**VIRGINIA ELECTRIC AND POWER COMPANY**  
**NORTH ANNA POWER STATION UNITS 1 AND 2**  
**PROPOSED TECHNICAL SPECIFICATION CHANGES**  
**REVISED CONTAINMENT ANALYSIS**

Attachment 1	Discussion of Changes
Attachment 2	Mark-up of Technical Specifications Changes
Attachment 3	Proposed Technical Specifications Changes
Attachment 4	Mark-up of ITS Changes
Attachment 5	Proposed ITS Changes
Attachment 6	Significant Hazards Consideration Determination

**Attachment 1**  
**Discussion of Changes**

**Figure 3.6-1: Containment Air Partial Pressure versus Service Water Temperature**

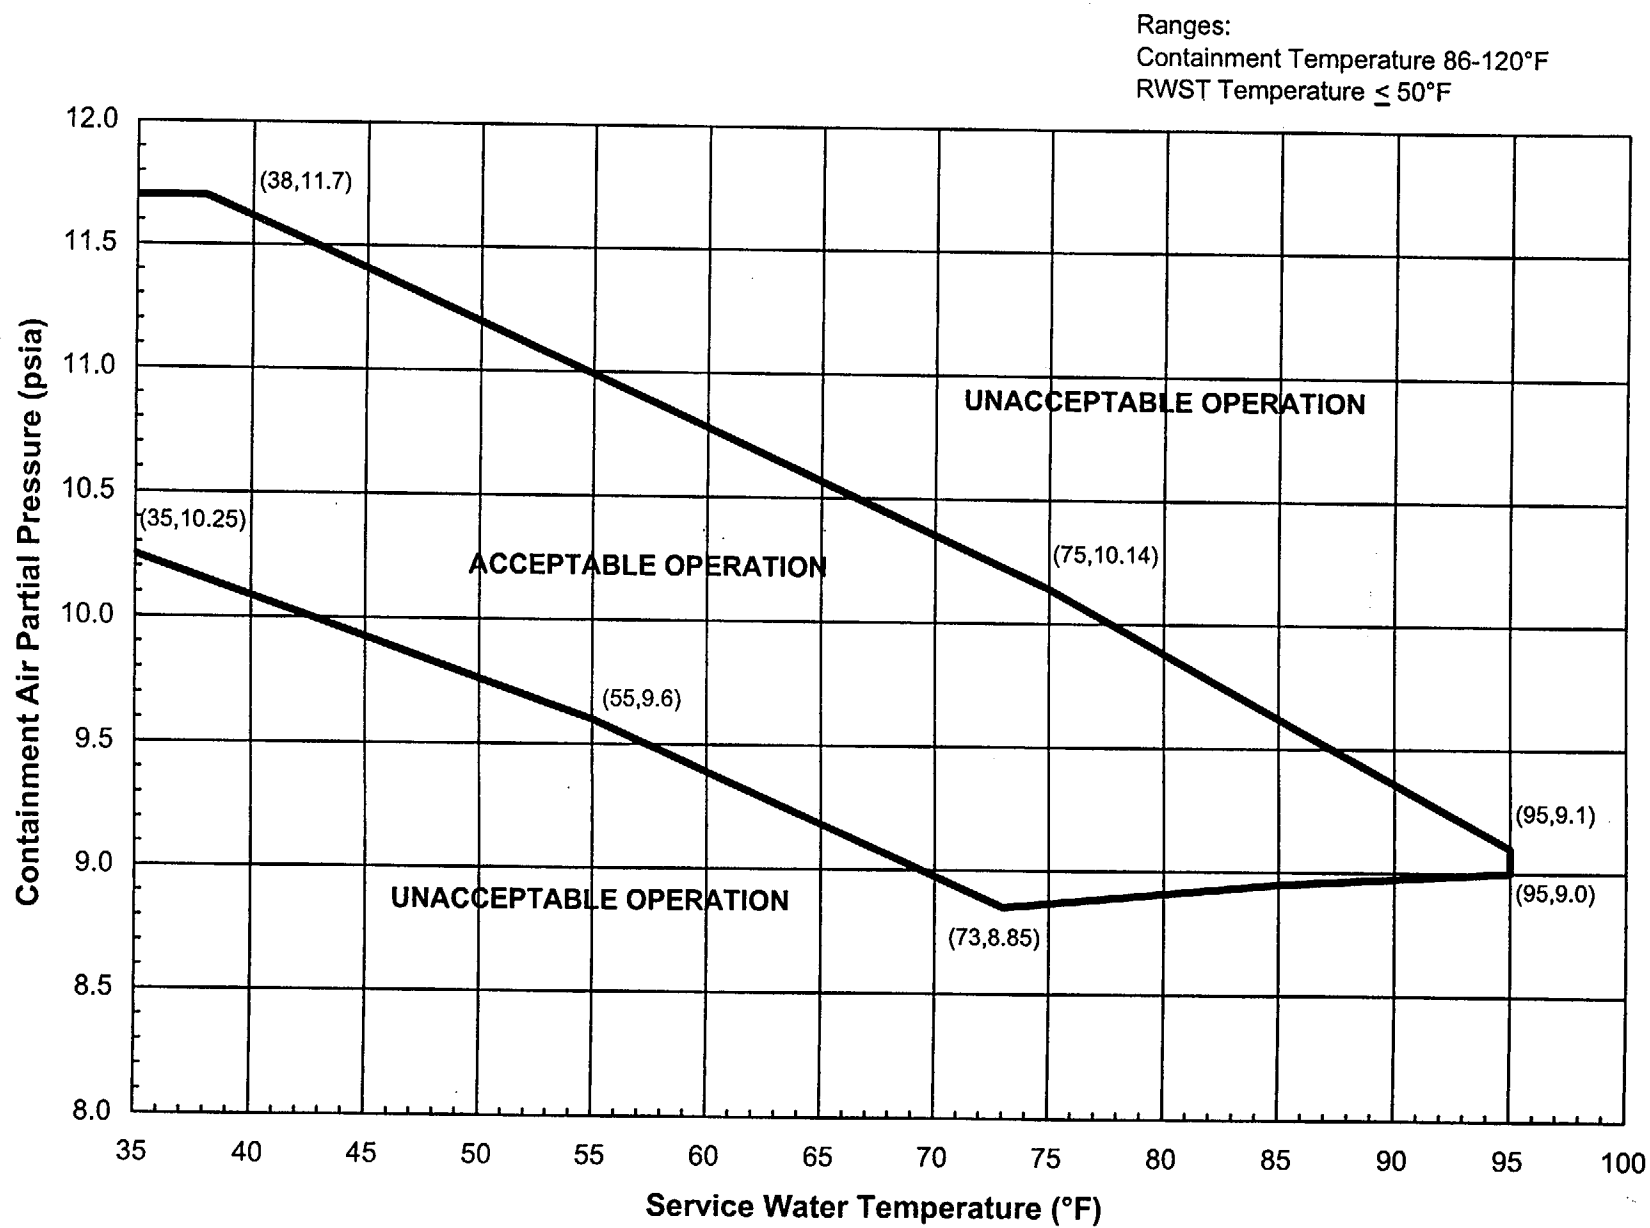
With the containment internal air partial pressure outside the acceptable operation region shown on Figure 3.6-1, restore the internal air partial pressure to within the limits within 1 hour or be in at least HOT STANDBY within the next 6 hours and in COLD SHUTDOWN within the following 30 hours. |

Figure 3.6-1: Containment Air Partial Pressure versus Service Water Temperature

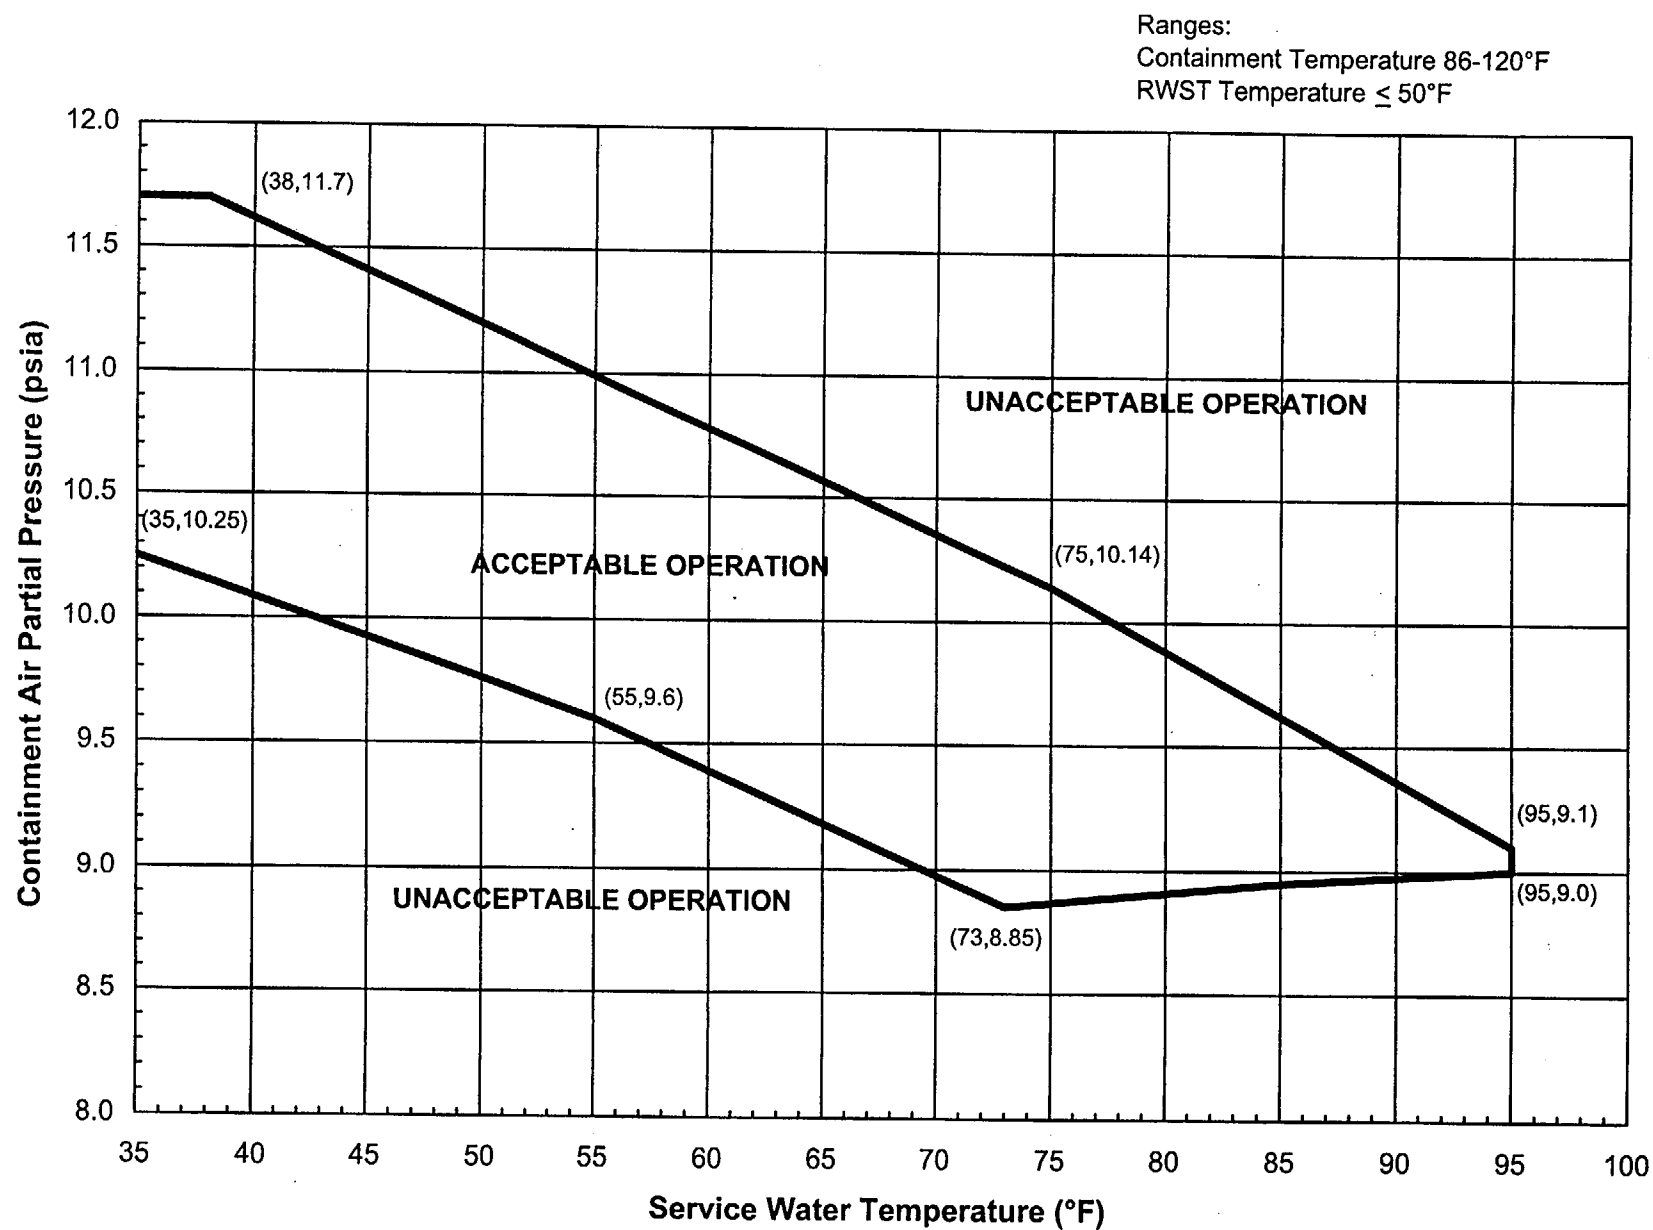
With the containment internal air partial pressure outside the acceptable operation region shown on Figure 3.6-1, restore the internal air partial pressure to within the limits within 1 hour or be in at least HOT STANDBY within the next 6 hours and in COLD SHUTDOWN within the following 30 hours. |

Figure 3.6.4-1 (page 1 of 1)  
Containment Air Partial Pressure Versus  
Service Water Temperature

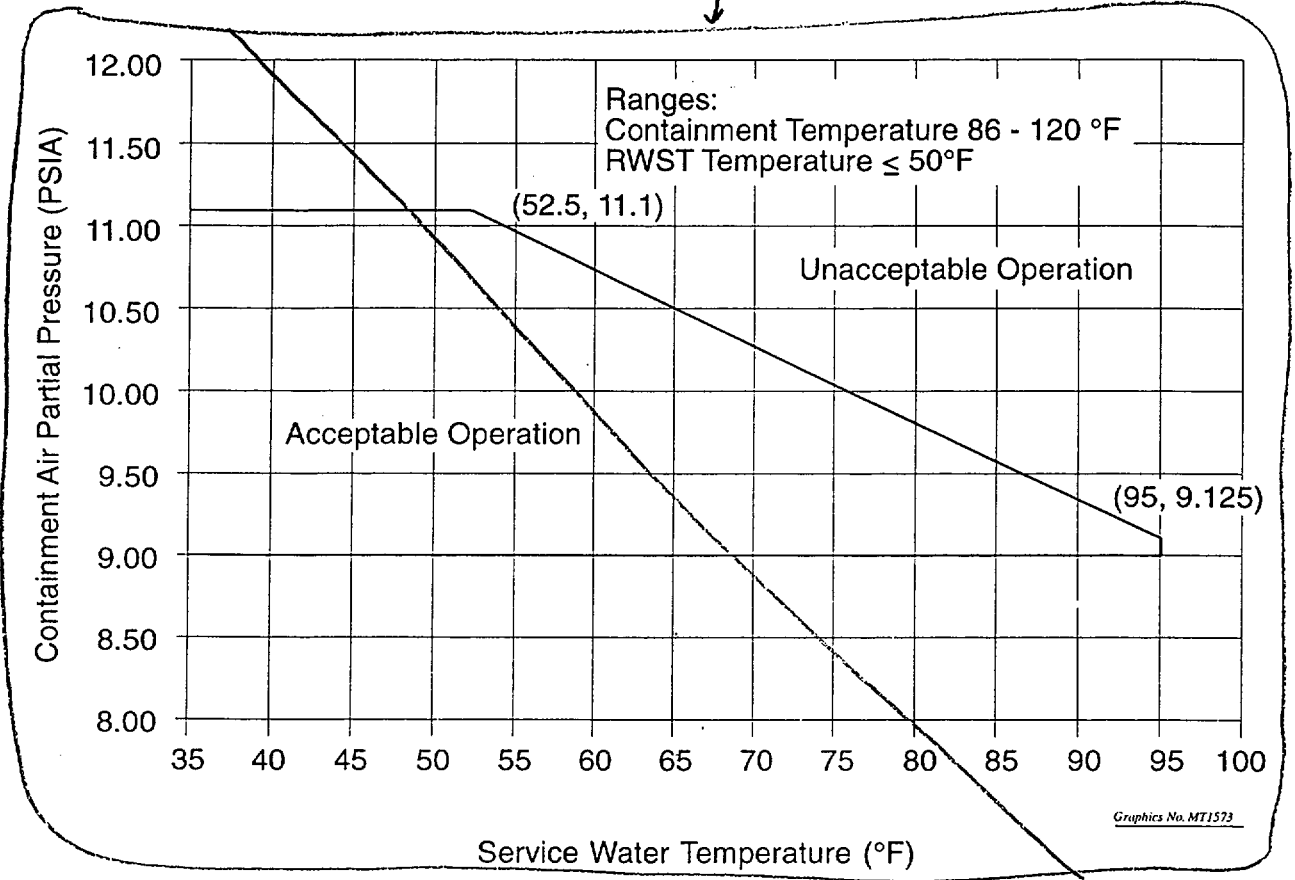
The containment air partial pressure versus service water temperature operating curve in Figure 3.6.4-1 will be changed to the new curve. In addition, the text will be slightly modified to remove the reference to a constant air partial pressure lower limit of 9.0 psia, which is not a feature of the revised figure. The Bases to ITS 3.6.4 will be updated with applicable analysis inputs and results. These changes are consistent with the proposed CTS changes described in Section 3.1.1.

Replace with  
new Figure  
3.6.4-1

Figure 3.6.4-1 (page 1 of 1)  
Containment Air Partial Pressure Versus  
Service Water Temperature

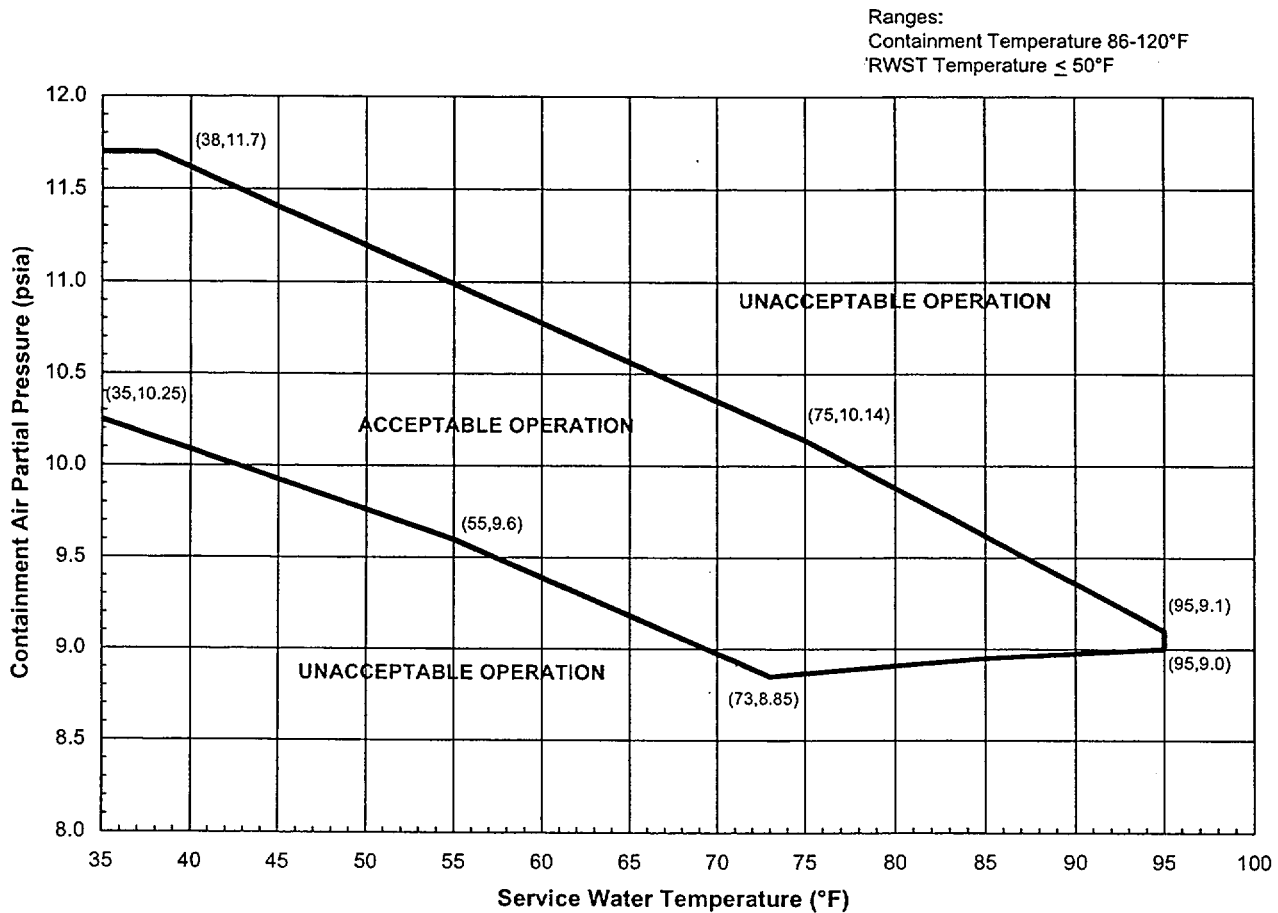
LC0 3.6.4 Containment air partial pressure shall be within the acceptable operation range shown on Figure 3.6.4-1.
